**Development Permit Panel
Electronic Meeting**

1. DEVELOPMENT PERMIT 23-031545
(REDMS No. 8206668)

PROPERTY LOCATION: 8680 Alexandra Road

**DP 23-031545 - COMMERCIAL DEVELOPMENT (TWO BUILDINGS) IN THE CITY
CENTRE AREA PLAN**

1 BUILDING 1 - FIRST FLOOR PLAN
Scale: 3/64"=1'-0"

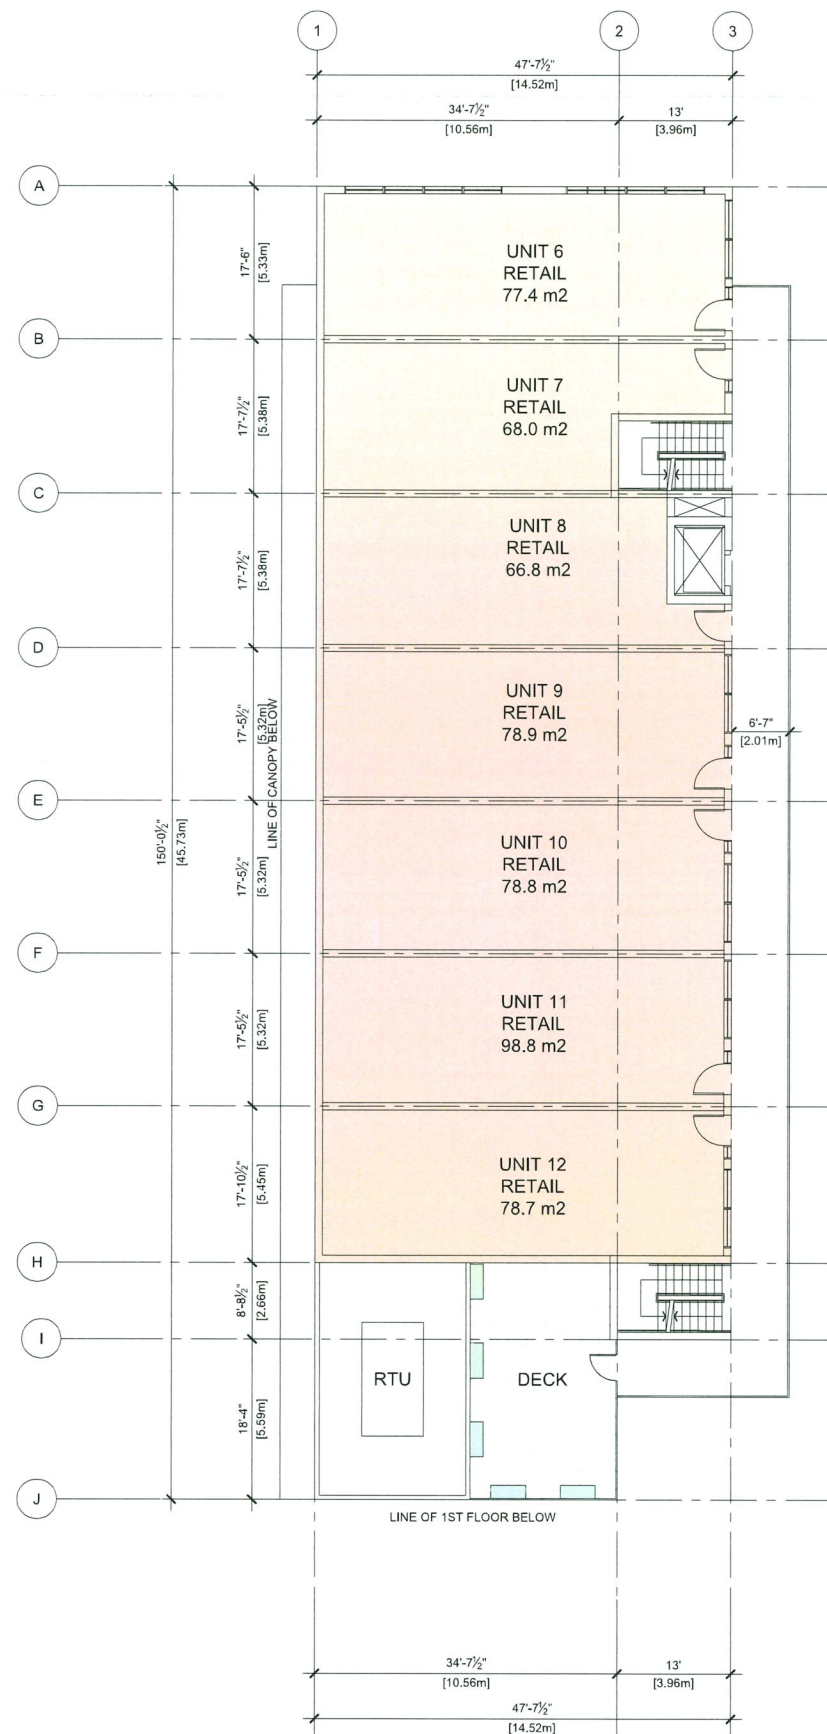
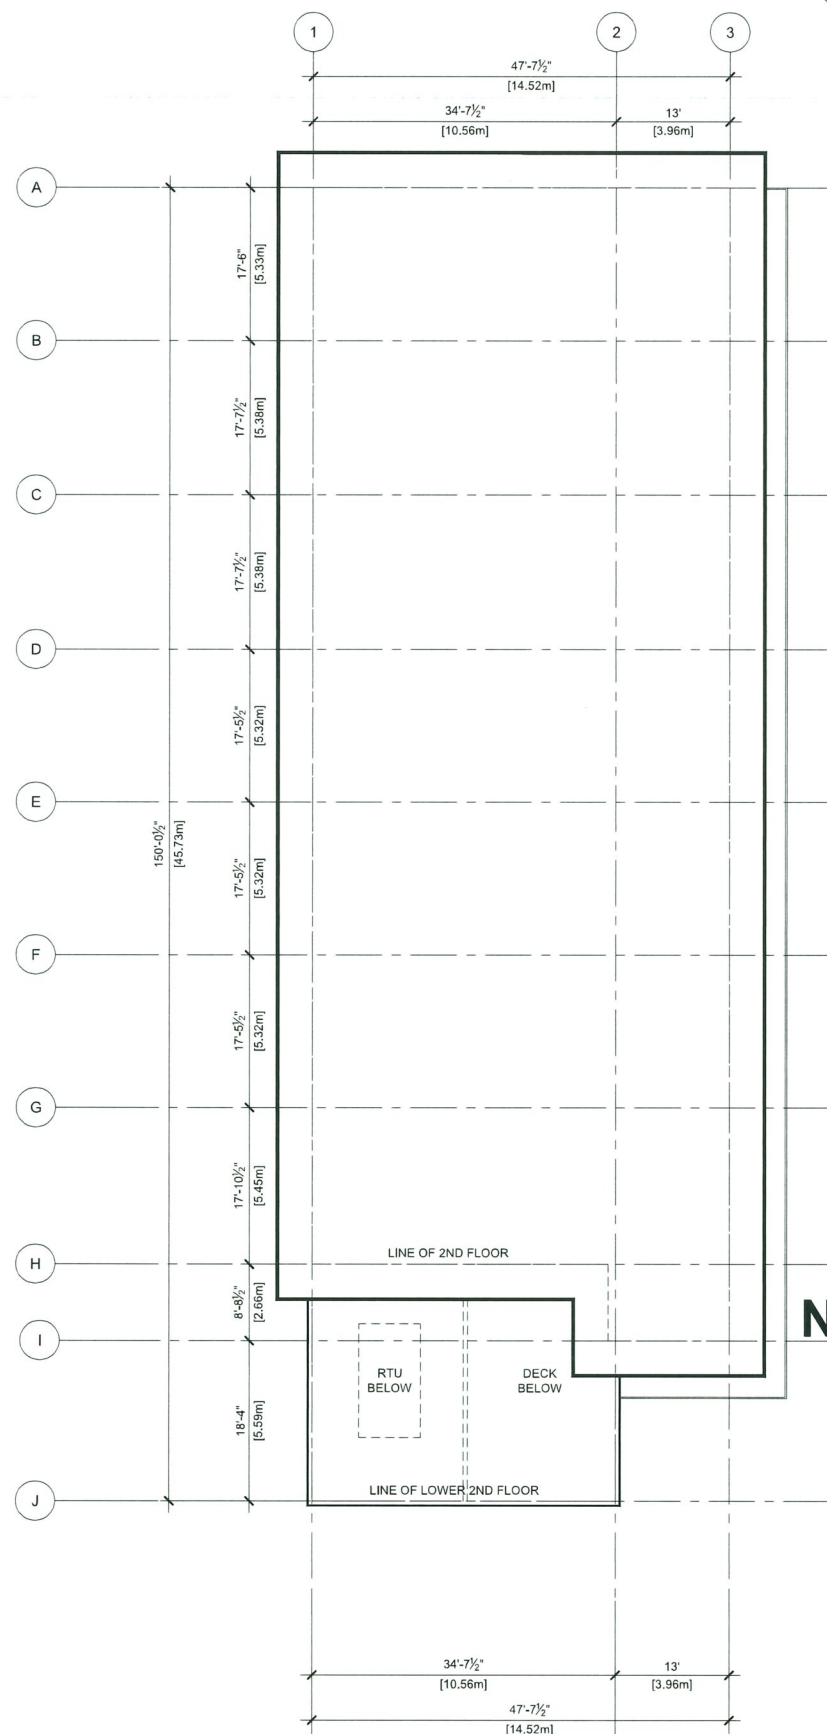
- appreciate the applicant's presentation of the project; *Noted with thanks.*
- consider flipping Building 1 on Lot B and shift the building to the east side of the property so that the front rather than the back of the building would be facing the front of the future building on Lot A; this would create a more open space for Lot A, provide a better view of Building 1 on Lot B from Lot A, resolve concerns regarding the west elevation of Building 1, and eliminate CPTED issues on the west edge and the narrow pedestrian pathway along the west property line; consider installing a transparent fence to help address the grade change along the west property line; ***Flipping Building 1 was considered but the original design has been retained for the following reasons:***

- investigate ways to provide a better view of Building 1 on Lot B from the future development on Lot A including flipping Building 1 on Lot B; would prefer flipping Building 1 on Lot B as the existing trees along the east property line would soften the east edge and improve the visibility of the CRUs' signage in Building 1 from Alexandra Road; also consult with the City regarding feasible options for the site's vehicular entrance on Alexandra Road; *Building 1 remains the same location but a range of design improvements have been implemented to enhance the west elevation, including larger window areas, continuous weather protection canopies, extended roof overhangs, varied materials and colors, and improved CRU signage visibility. These updates collectively create a more articulated, welcoming, and pedestrian-friendly west façade while maintaining the building's original orientation.*

- agree with the Panel comment that the planning and layout of the site needs further consideration; flipping Building 1 might conflict with existing trees but overall, would contribute to creating an improved urban environment that would benefit Lot A and Lot B, and provide an opportunity for a contiguous surface parking area and an integrated stormwater management for both lots; ***Building 1's location remains the same as before, but additional design enhancements have been made to achieve better site and building design outcomes, including larger window areas, continuous weather protection canopies, extended roof overhangs, varied materials and colors, and improved CRU signage visibility. These updates collectively create a more articulated, welcoming, and pedestrian-friendly west façade while maintaining the building's original orientation***

- ***Elevation design has been refined to activate the west building face in the interim and in the future. If building 1 isn't back facing Lot A, it's back will be facing neighbor 8740 Alexandra site on the other side. It is hard to say Lot A is more important than the 8740 lot. The location of the SRW between proposed Lot A and B provide the current orientation of Building 1 with opportunities for additional glazing along the west side of the building face, which has now been provided.***

1 EAST ELEVATION
Scale: 1/16"=1'-0"

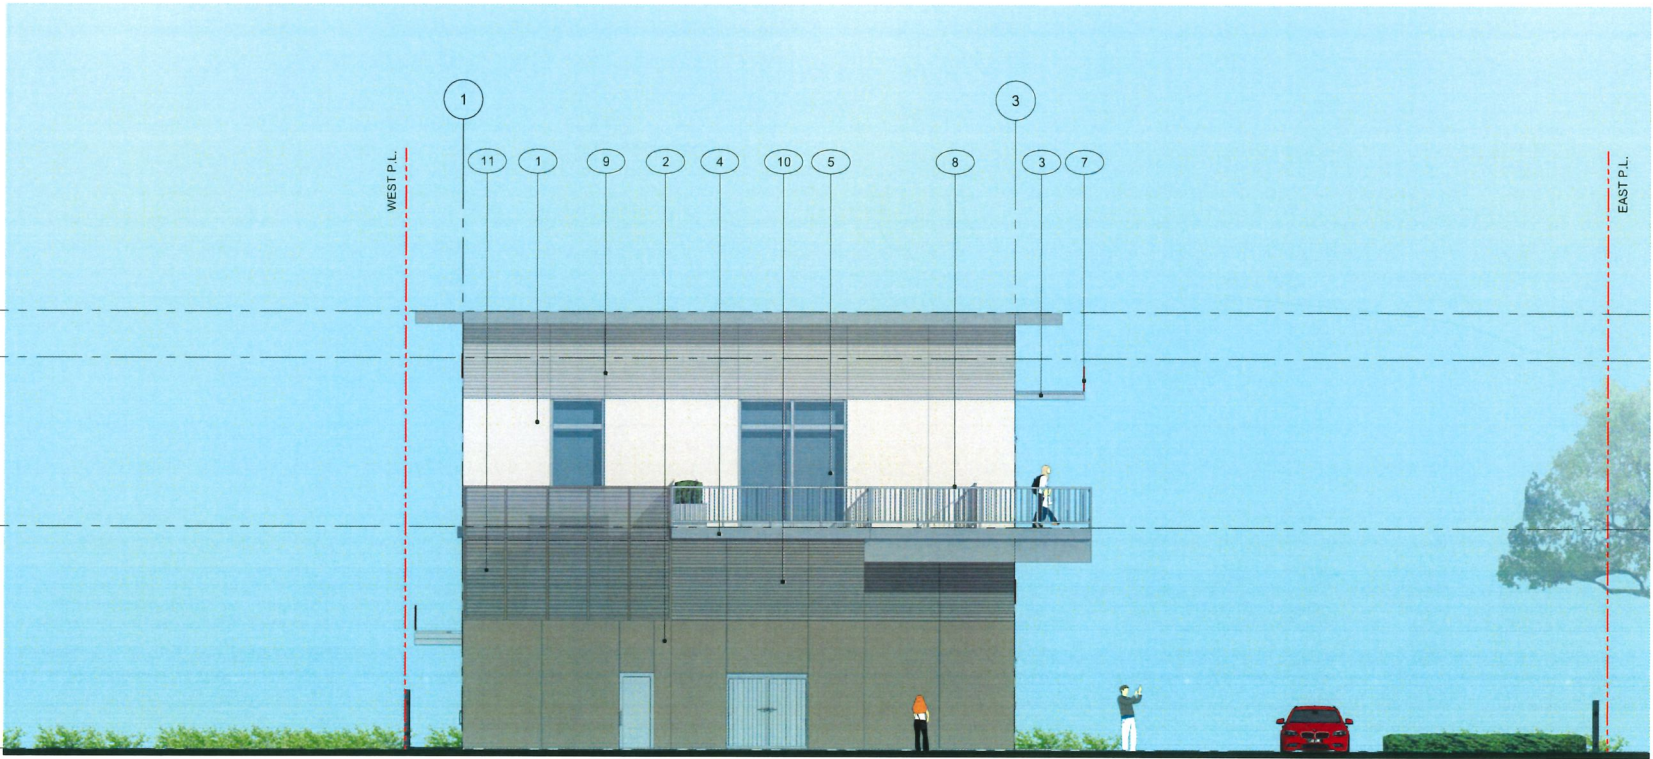
- consider eliminating the break on the canopy above the second floor terrace of Building 1 to provide a continuous canopy that matches the continuous terrace; *A continuous canopy now wraps around the building perimeter and the top of the whole first floor is on the same level. Refer to the updated building elevation and 3D.*

- provide clarity on the use cementitious panels as they are not shown on the drawings with any EasyTrim reveal which is preferable than having aluminum trims; ***EasyTrim reveal lines are provided and shown on building elevation and 3D.***

1 SECTION1
Scale: 3/64"=1'-0"

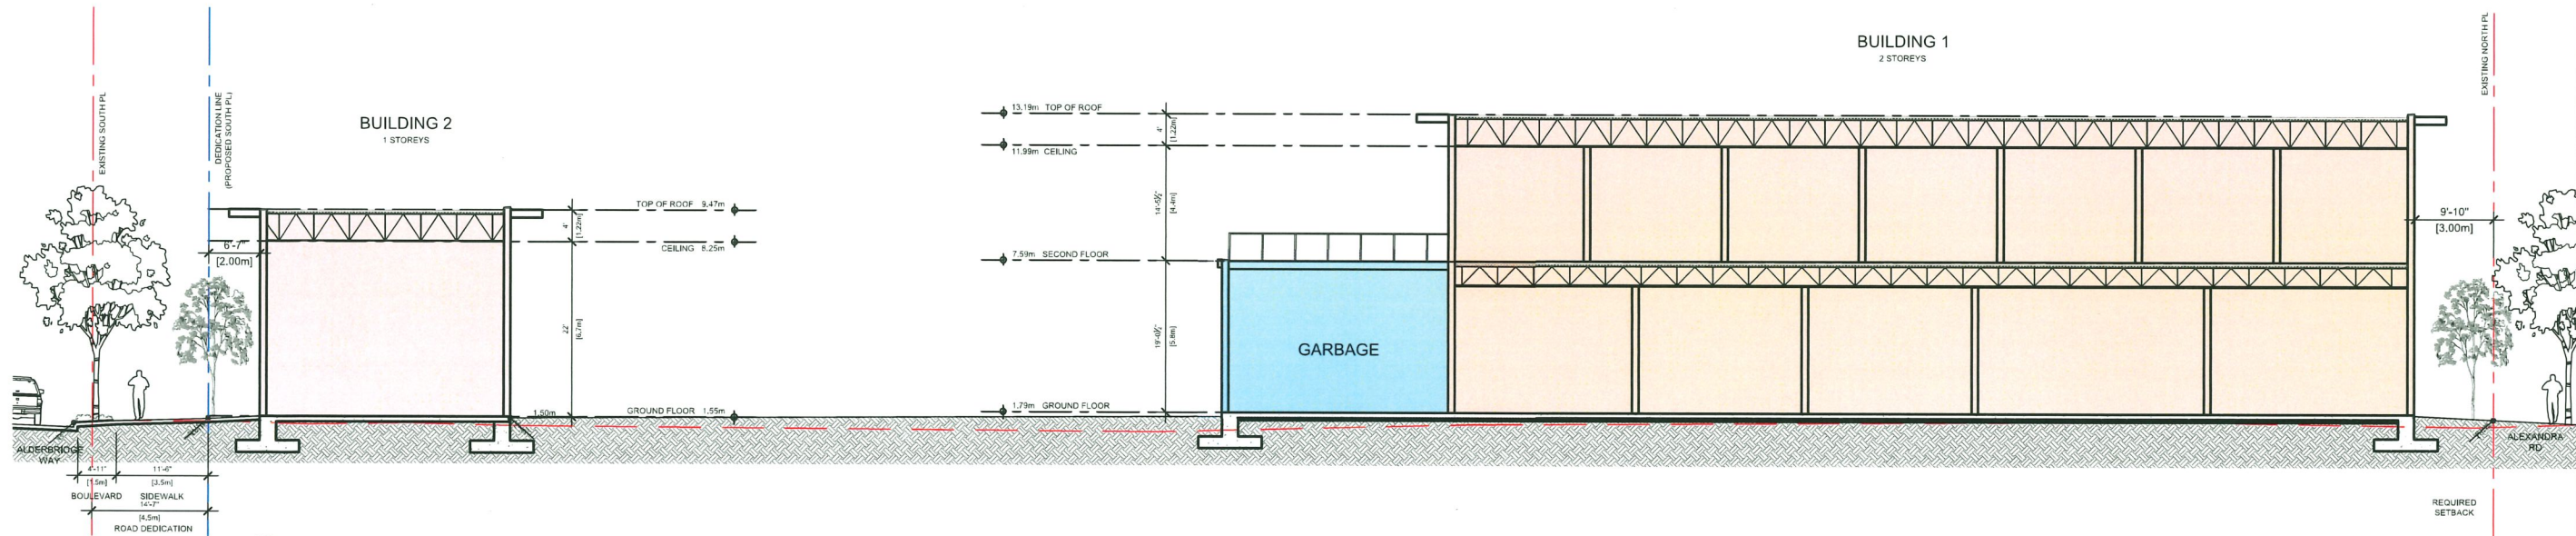
- the roof deck patio on top of the mechanical and garbage and recycling rooms poses a CPTED concern as it is difficult to provide surveillance from the ground or from the second floor CRUs; a building section shown on the package provided by the applicant indicates that the patio is on the same floor level as the second level CRUs; consider following this section plan to provide accessibility to the patio from adjacent CRUs and enhance its usability; *The roof deck has now been raised to be on the same elevation as the CRUs of the second floor.*

- consider raising the height of the patio on top of the mechanical and garbage recycling rooms to match the height of the terrace for the second floor CRUs so it can be accessed via the elevator servicing the second floor CRUs; the landscaped patio will provide a nice outdoor amenity for the CRUs and enhance their rentability; *Roof deck now has the same elevation as the CRUs of the second floor.*
